NUCLEAR ENERGY INSTITUTE

**SUBJECT:** Response to Questions on Addendum 2 to EPRI Performance  
Prediction Methodology Software, Version 2.0

**Project Number: 689**

**Responses to NRC Comments on  
Addendum 2 to EPRI TR-103237-R2**

Figure 1. Determination of Zero Offsets for Valve #24

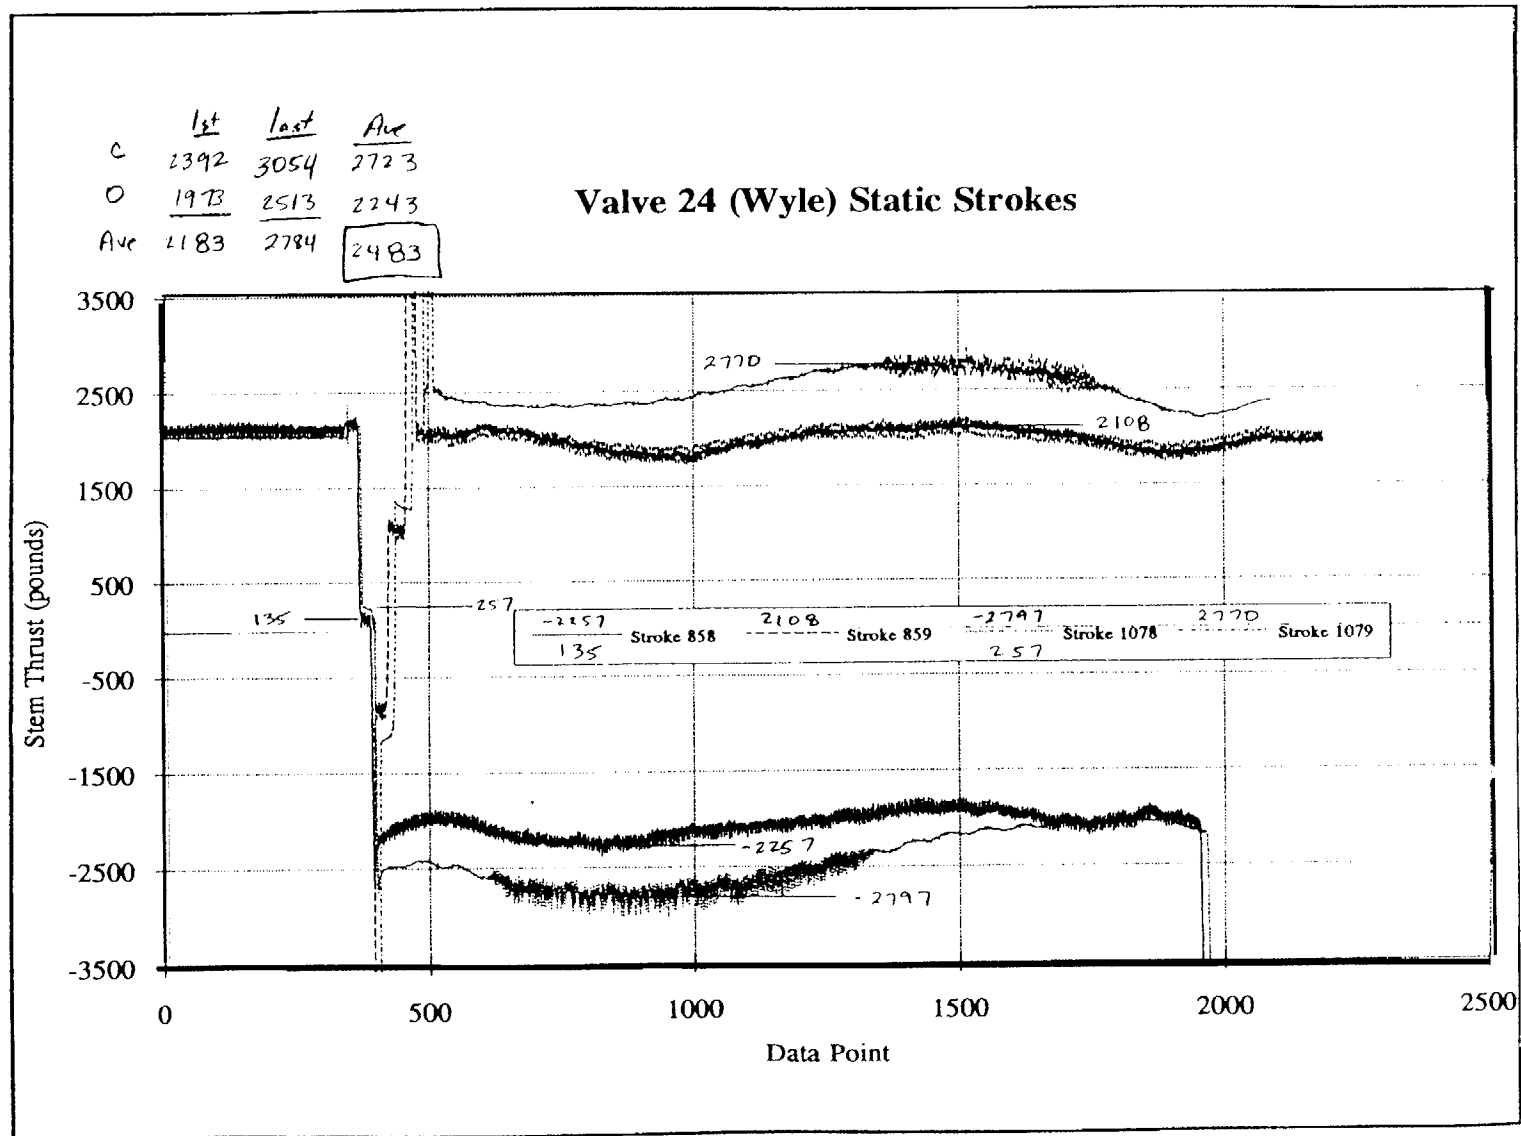
Explain why certain data in Table 1 of Appendix B to EPRI Topical Report TR-103237, Addendum 2, are different from the original test data in previously published EPRI test reports. For example, see the data in EPRI TR-103674-V9P1, "EPRI MOV Performance Prediction Program - High Pressure Cold and Hot Water Blowdown Facility Test Report, Volume 9, Part 1: Test Results for MOV #24."

We assume this comment refers to the term  $F_{\text{measured}}$  (maximum measured stem thrust) listed in Table 1 of Appendix B of TR-103237-R2, Addendum 2. Values in Table 1 are taken from EPRI TR-103229 and MPR Calculation 140-078-TW14 for solid and flexible wedge gate valves. These values may differ from values presented in the Wyle flow loop test reports (e.g., EPRI TR-103674-V9P1) because of adjustments to account for zero offsets in the data. During the EPRI MOV Program, we performed a detailed analysis of the static test data for each valve to determine if there were zero offsets in the data that should be considered when evaluating the data. For some valves, we found that zero offset adjustments were needed. MPR Calculation 140-81-TW2 determines the zero offsets from the static test data, and MPR Calculation 140-078-TW14 applies the zero offset adjustments to the maximum measured thrust for each valve stroke. The Figure 1, taken from MPR Calculation 140-81-TW2, shows the evaluation of static test data for Valve #24 (strokes performed at Wyle, not at Siemens). As shown, the zero offset for the first static closing stroke performed was 135 pounds, and the zero offset for the last static closing stroke was 257 pounds. Accordingly, in MPR Calculation 140-078-TW1, a zero offset adjustment of 196 pounds (the average of 135 and 257) was used for all Valve #24 strokes performed at Wyle. Therefore, values of measured stem thrust listed in TR-103229 and Addendum 2 to TR-103237-R2 for Valve #24 are 196 pounds higher than shown in TR-103674-V9P1.

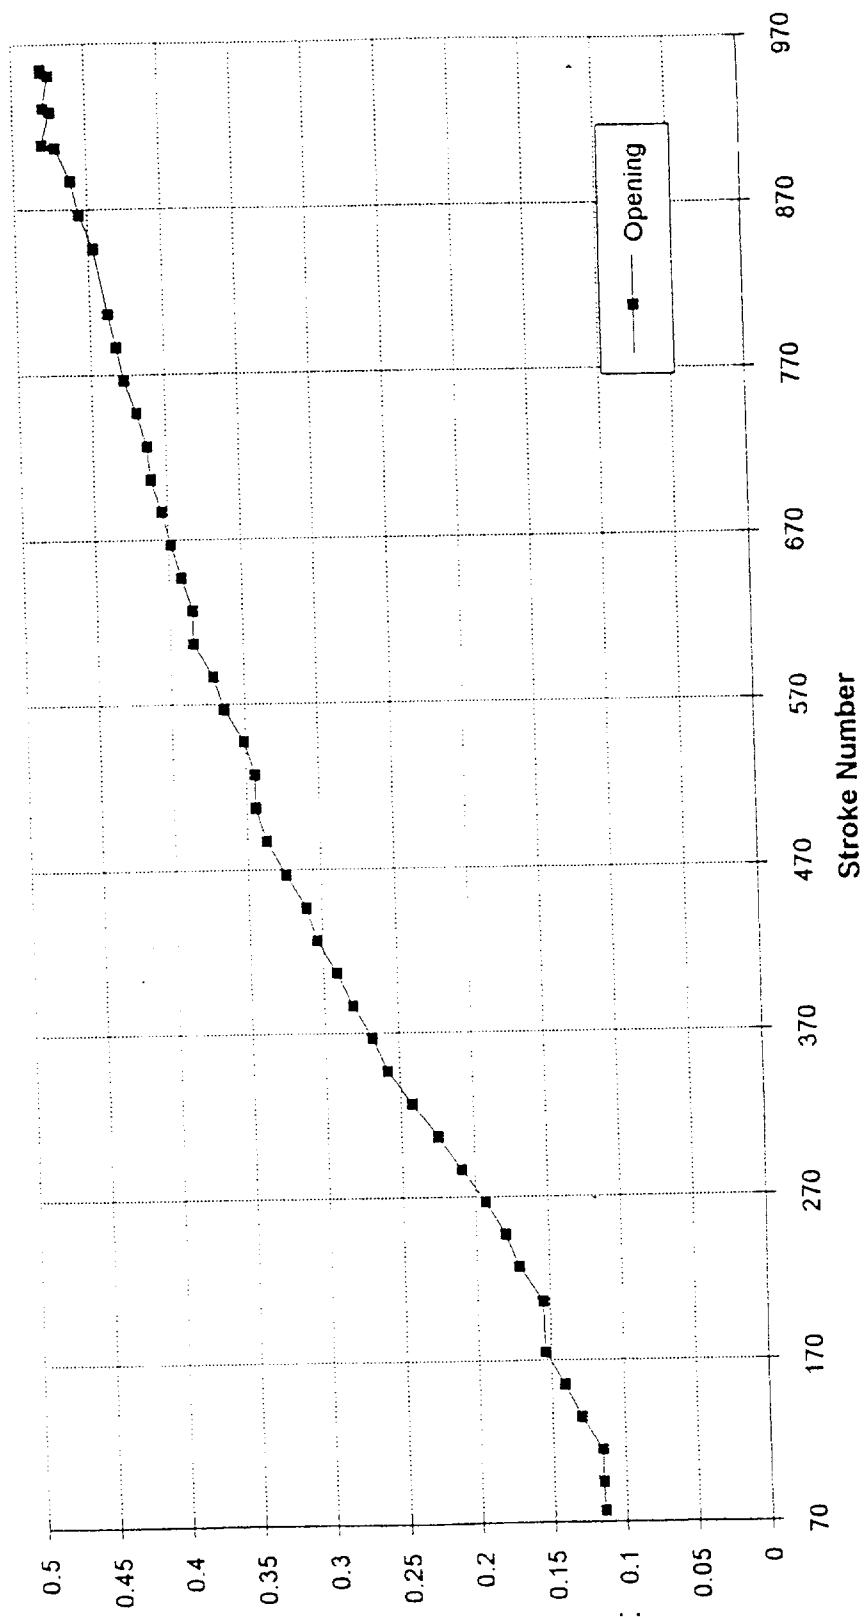
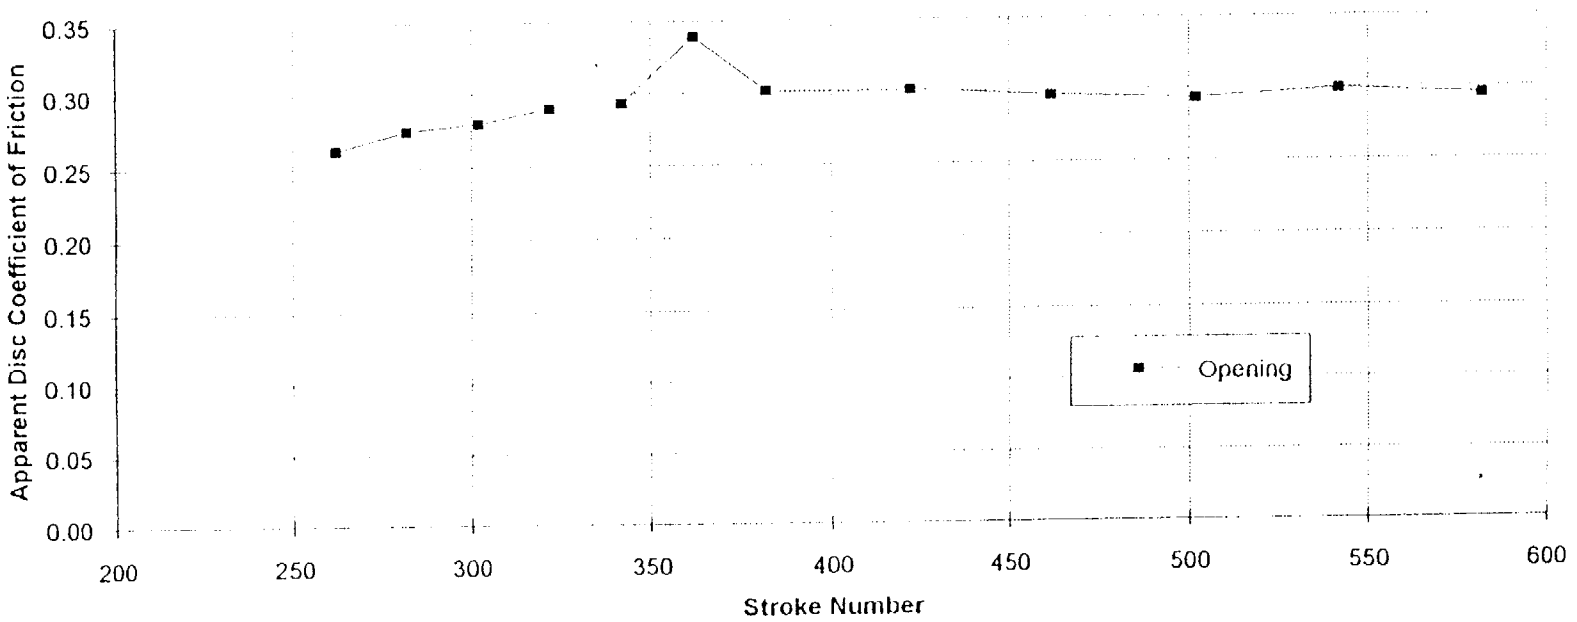
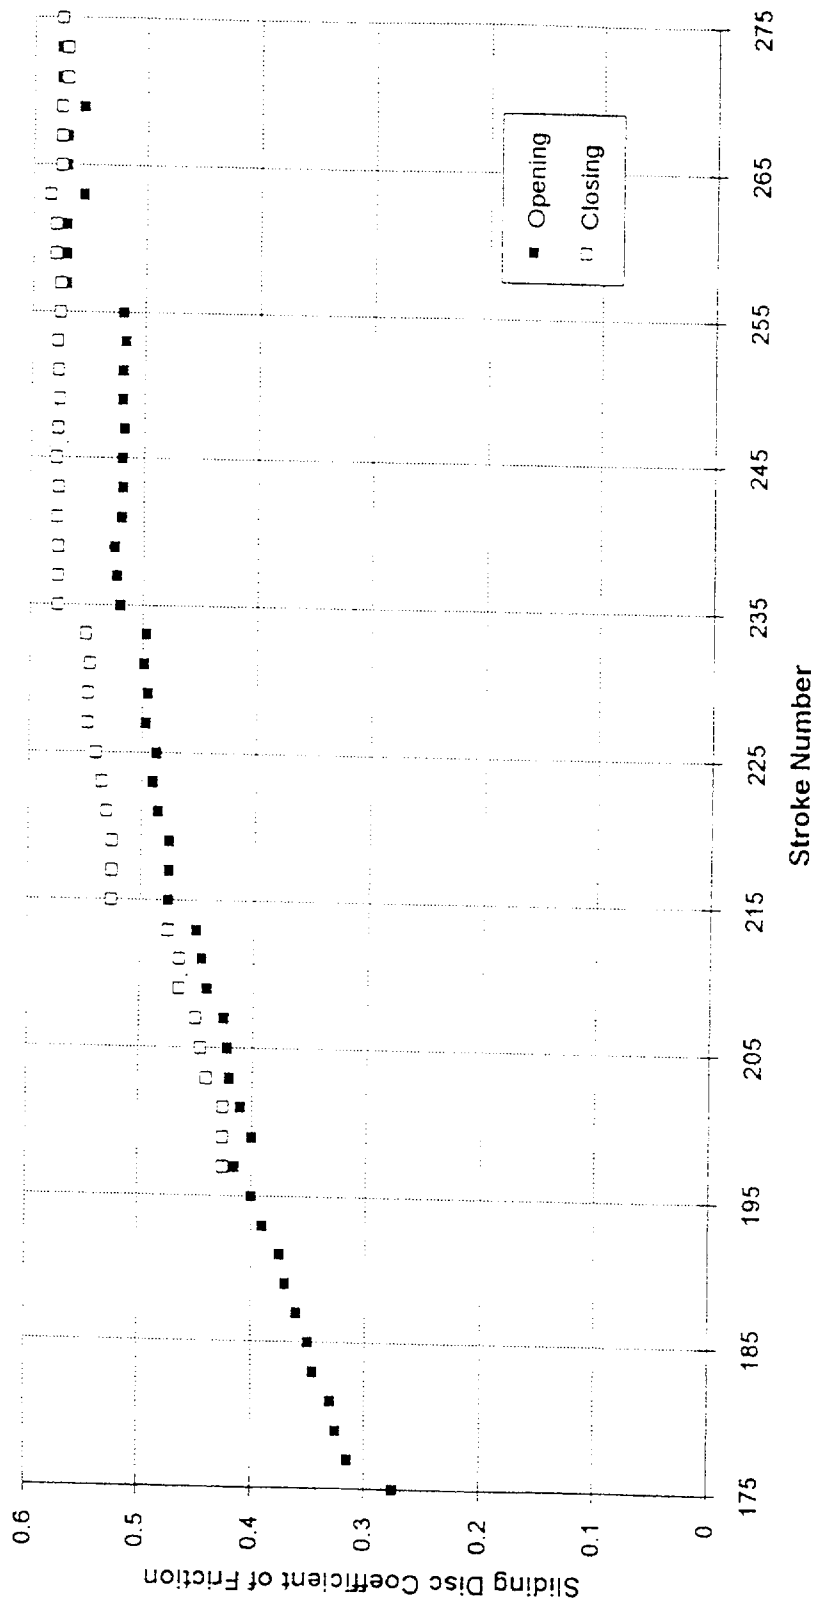
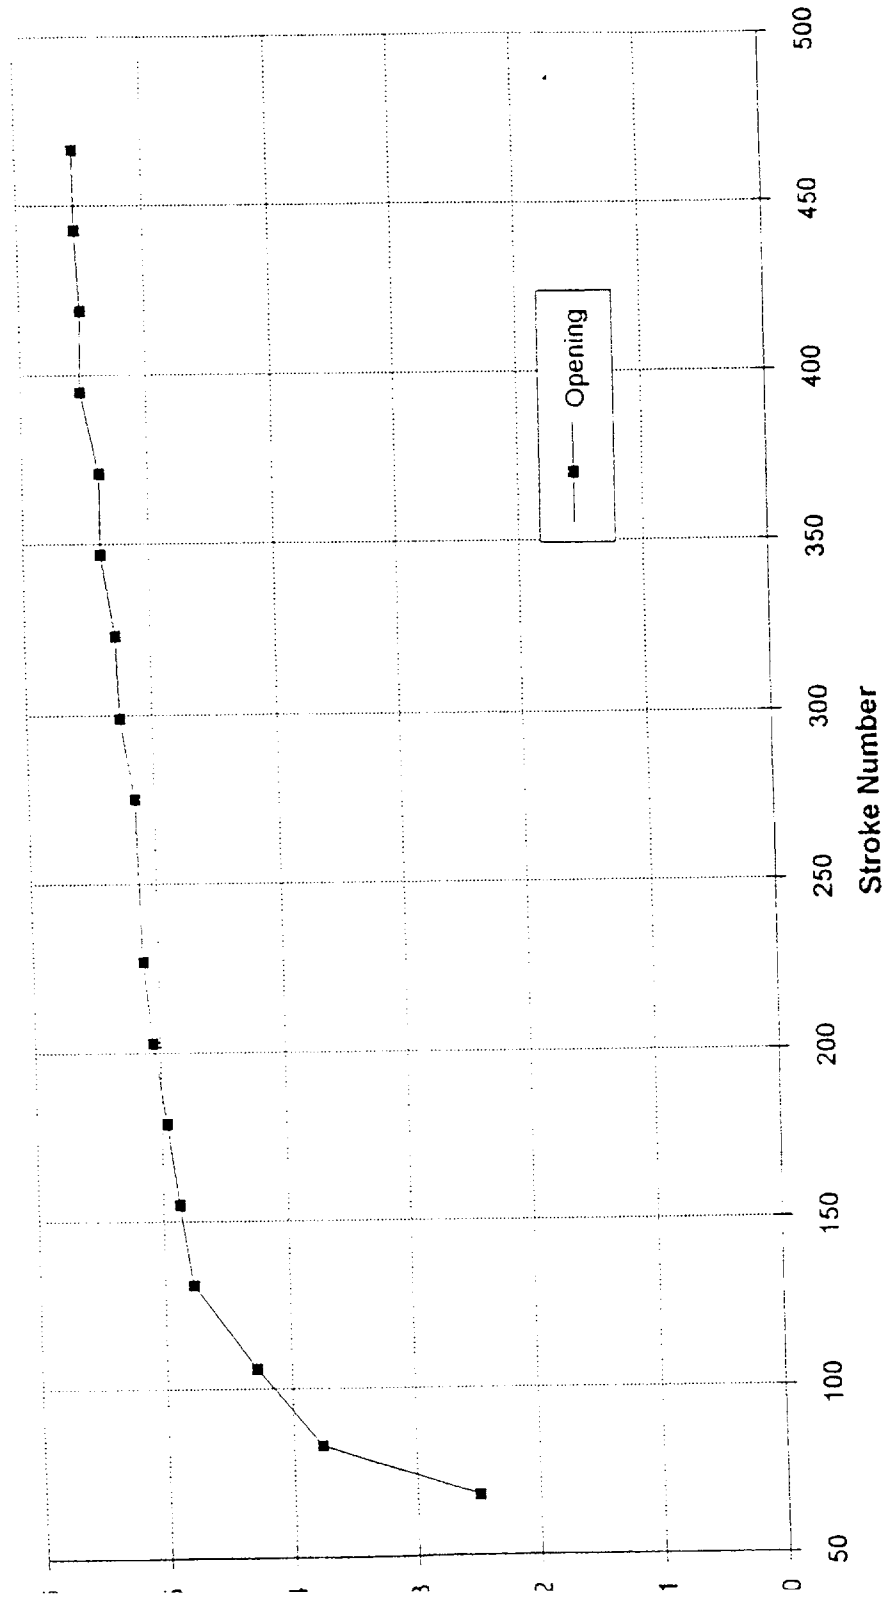
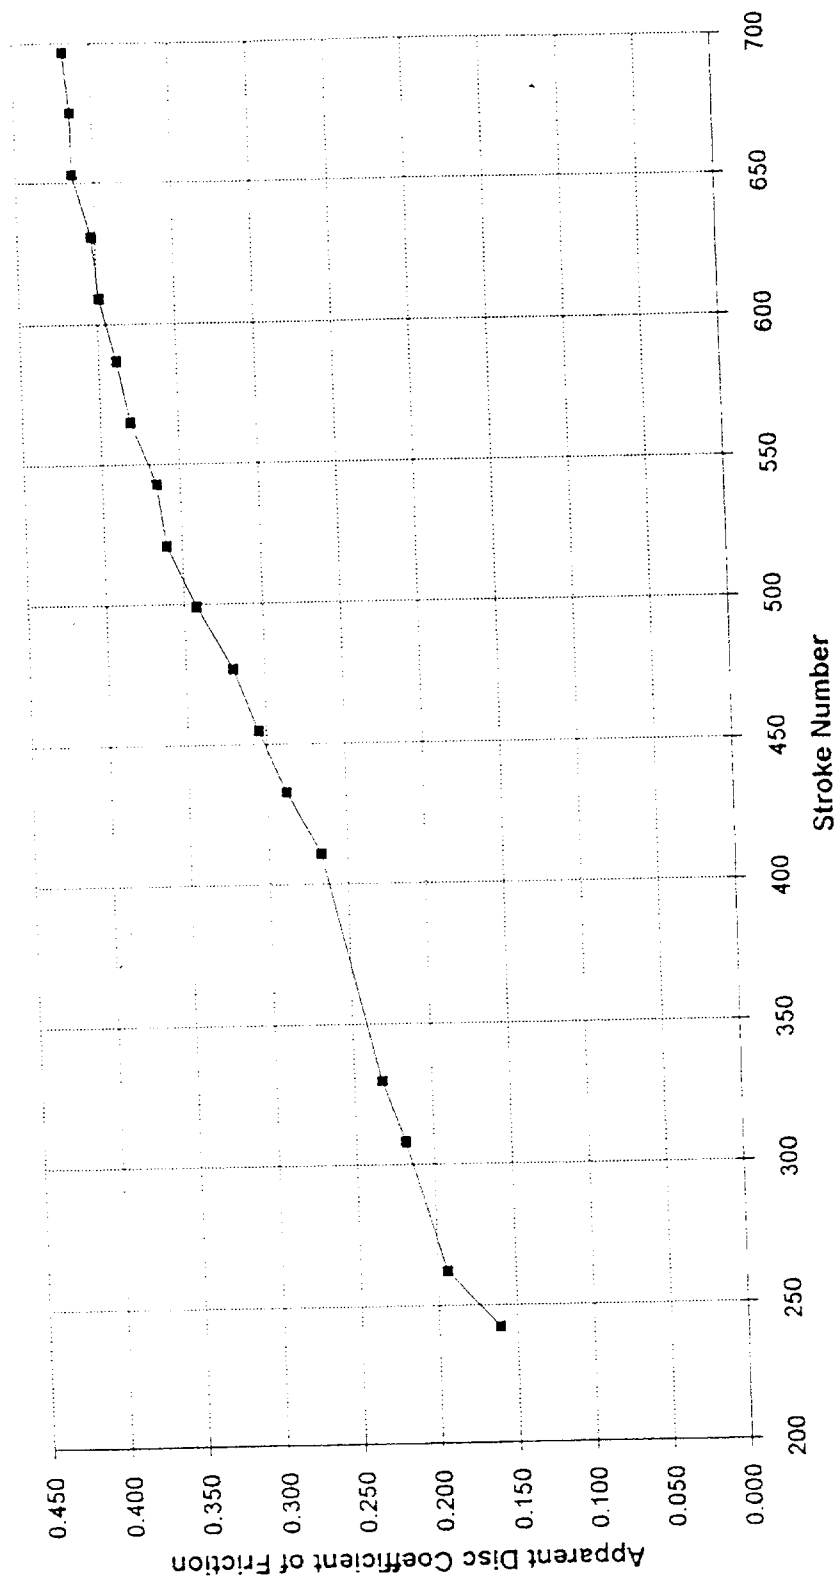
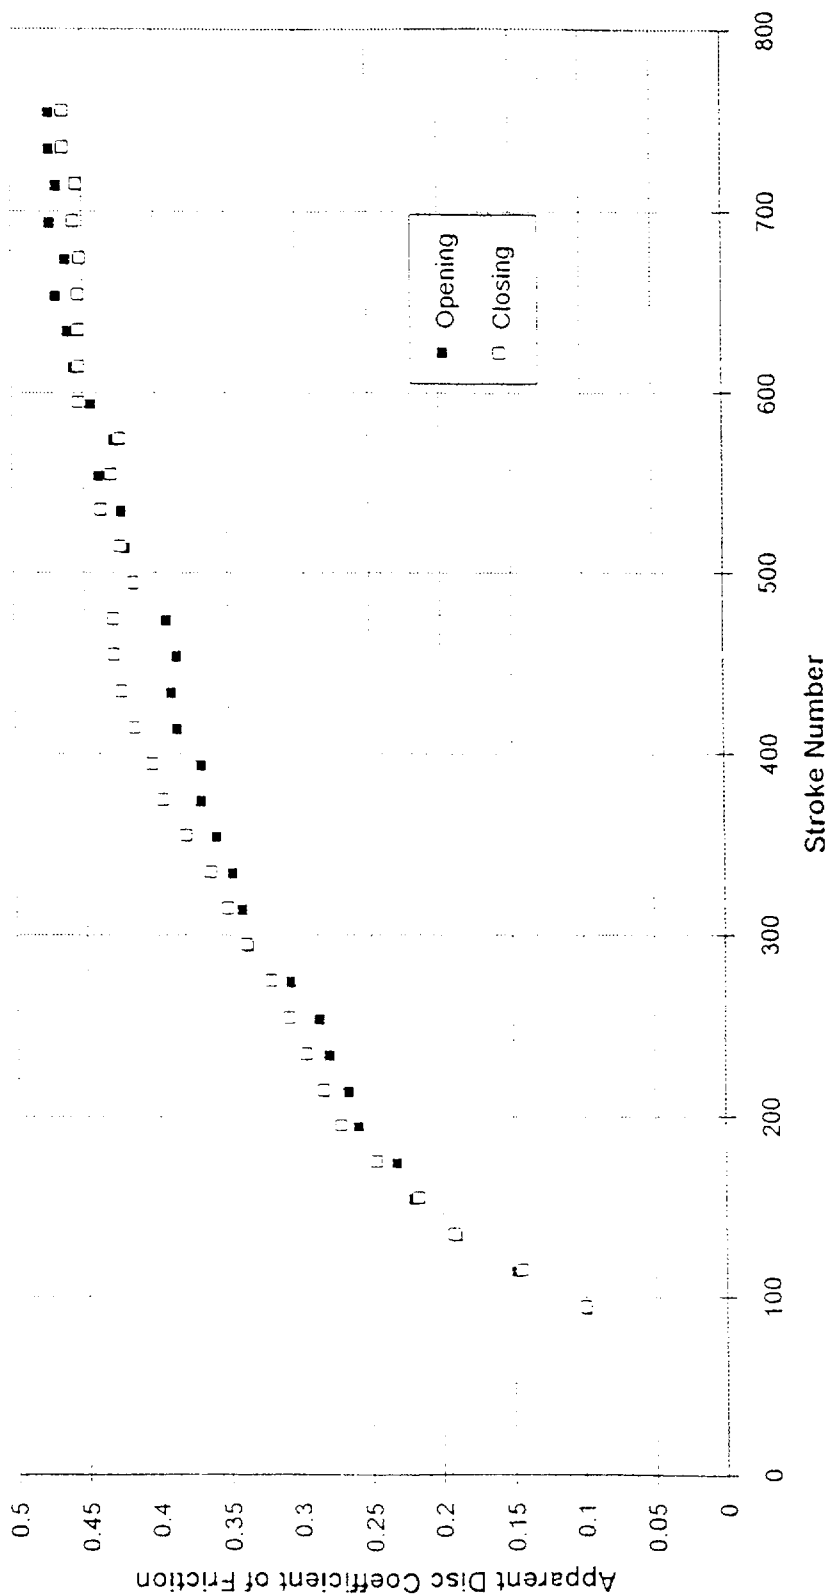
EPRI Topical Report TR-103237, Addendum 2, assumes that the EPRI MOV PPM thrust predictions for gate valves are conservative. However, the overall test data obtained by EPRI (including data used to support the Thrust Uncertainty Method) indicate low to moderate friction coefficients for the test valves. Further, low loading conditions applied to the valves during testing might result in significant scatter in the test data. Explain the basis for the assumption that the EPRI test valves were fully preconditioned in light of this information.

The Wyle flow loop test reports include plots of measured disk-to-seat COF versus stroke number for the preconditioning strokes (attached) and measured apparent disk-to-seat COF versus stroke number for the valve flow tests. The table below summarizes the information in these plots for the 14 gate valves used to determine the average predictions ratios in the Thrust Uncertainty Method.

- With the exception of MOV #29, each test valve received at least 90 preconditioning strokes (and most received more than 400). It is unlikely that many nuclear plant MOVs have been stroke as many as 90 times with DP or flow.

- For all valves except MOV #6, the range of COFs for the flow tests was consistent with the final precondition COF. This observation supports the conclusion that the seat preconditioning was maintained between the preconditioning strokes and the flow tests. Only two strokes of MOV #6 (both cold water) were used in determining average prediction ratios. If these two strokes were eliminated from this evaluation, the average prediction ratio for cold water strokes would increase from 0.697 to 0.704. This difference is judged negligible. Note that in most cases, the range of apparent COFs for the flow tests is higher than the final COF for preconditioning. This result is expected for two reasons. First, the preconditioning strokes were performed at 100% DP and some of the flow loop tests were performed at lower DPs; Stellite COF is typically higher at low DPs. Second, there are affects other than seat friction that may be included in the apparent COFs for the flow tests, for example, stem bending and the Bernoulli effect for opening strokes.
